Access Compliance Report Public Rights-of-Way (Curb Ramps)

Main Street: TRISTANIA_ST Cross Street: STRAWFLOWER_ST Location: SW

ADA ID: RPAT211102133350 Ramp Type: Type 4 - Parallel Initial Pass/Fail: Fail Overall Compliance: No Severity Score: 2

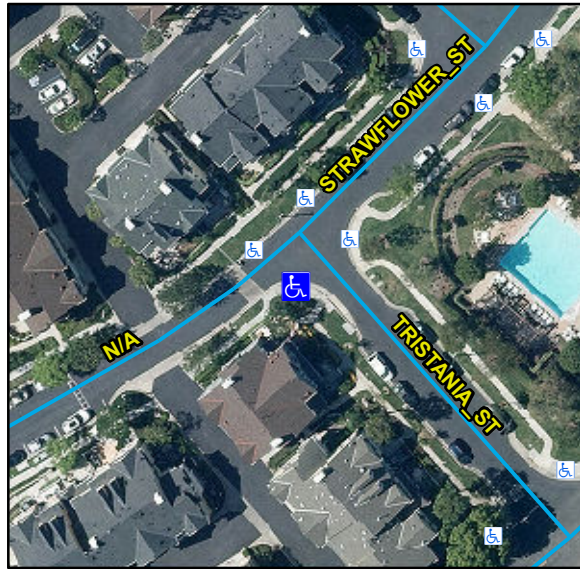
Compliance	Description	Data	Compliance	Description	Data
N/A	Ramp Length LT (in)	110	N/A	Ramp Length RT (in)	105
Yes	Ramp Width LT (in)	53	Yes	Ramp Width RT (in)	53
Yes	Ramp Run Slope LT (%)	4.7	Yes	Ramp Run Slope RT (%)	6.2
No	Ramp Cross Slope LT (%)	2.3	No	Ramp Cross Slope RT (%)	3.1
N/A	Landing Present	N/A	N/A	DWS Provided	N/A
N/A	Landing Length (in)	N/A	N/A	DWS Contrast	N/A
N/A	Landing Width (in)	N/A	N/A	DWS Length (in)	N/A
N/A	Landing Run Slope (%)	N/A	N/A	DWS Full Width	N/A
N/A	Landing Cross Slope (%)	N/A		DWS Offset Type	N/A
N/A	Landing Movement Obstructed?	N/A	N/A	DWS Offset Left (in)	N/A
	Landing Movement Type	N/A	N/A	DWS Offset Right (in)	N/A
N/A	Landing Shared	N/A			
N/A	Clear Space	Yes			
N/A	Clear Space To Crosswalk (in)	N/A			
N/A	Marked Crosswalk 1	No	N/A	Marked Crosswalk 2	No
	Crossing 1 Direction	NE		Crossing 2 Direction	NW
	Marked Crosswalk 1 Width (in)	N/A		Marked Crosswalk 2 Width (in)	N/A

Remove & Replace Curb Ramp With Two New Directional Ramps or Equivalent.
